Barangaroo Part 3A Modification – Commercial FS

PREFERRED PROJECT REPORT

Harbour Foreshore Authority

Figure 3. Option 3 Modification Report

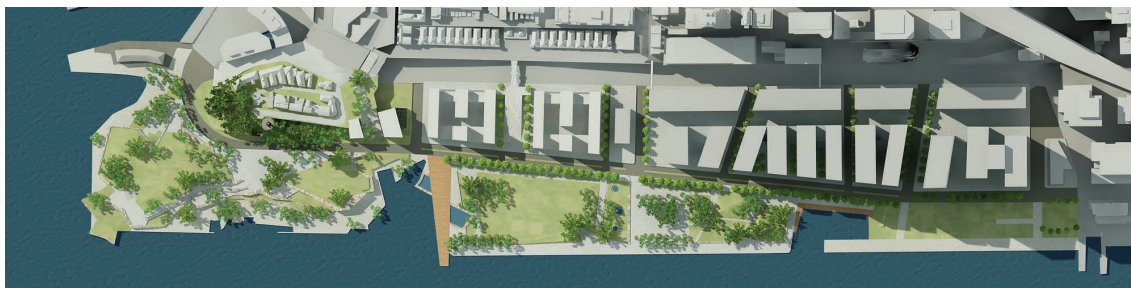
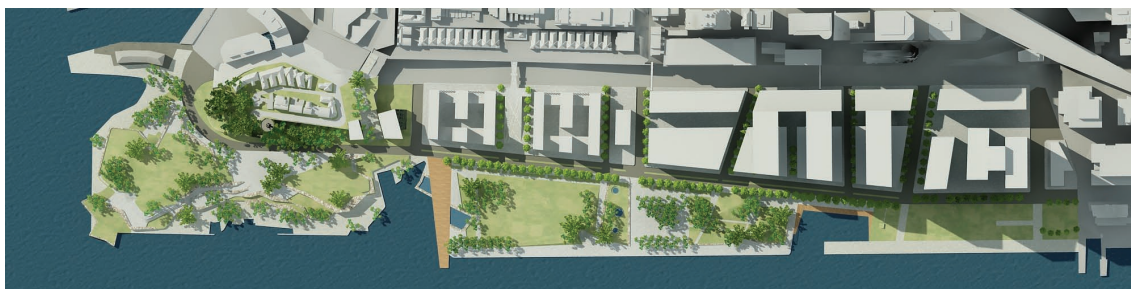
Concern was also expressed from a number of parties, including the City of Sydney and the winning design competition team regarding large floor plate buildings. The view was put that these may be acceptable where they are the exception within the context of a fine grained CBD urban form with a diversity of building types but that a series of large floor plate buildings will result in an unacceptable built form.

It appears from the submissions that the perception of the indicative building model was that this was the form that any future buildings on the site would take and hence many of the submissions raised issues about the lack of articulation and detailing, the length of the building walls, etc. The intent of the model was to show how the maximum additional floor space sought, 120,000m² could readily be accommodated within the existing approved block envelopes with significant scope for varying the form given that the model does not “build out” the block envelope box. Accordingly even with the additional 120,000m² of GFA proposed in the modification there still remains significant scope for the ultimate built form to be varied and thereby achieve design excellence.

To address this misconception additional 3D modelling has been undertaken to further illustrate how any future buildings on the site could readily accommodate the proposed additional GFA while at the same time achieving design excellence. 3D models were developed of the following:

The floorplate configurations of the three options are shown opposite in Figures 1 to 3 relative to the surrounding Barangaroo site.

In addition façade wrapping has been applied to provide a more realistic representation of what these floorplate configurations would look like as buildings rather than block massing as previously shown in the Modification Report. This exercise has been undertaken to make it easier to visualise the potential ultimate built form of the various options and to illustrate that many options exist for buildings that comprise the proposed GFA.

Appendix 3 provides three dimensional representations of the three different models from various viewpoints to enable comparison. From the models it is clearly evident that while the Option 1 CCP Indicative Building represents a built form that is consistent with the form of the existing Sydney CBD, so too do the two alternate options which include large floorplate buildings. All three options provide for a built form which is consistent with the key built form principles adopted for the site.
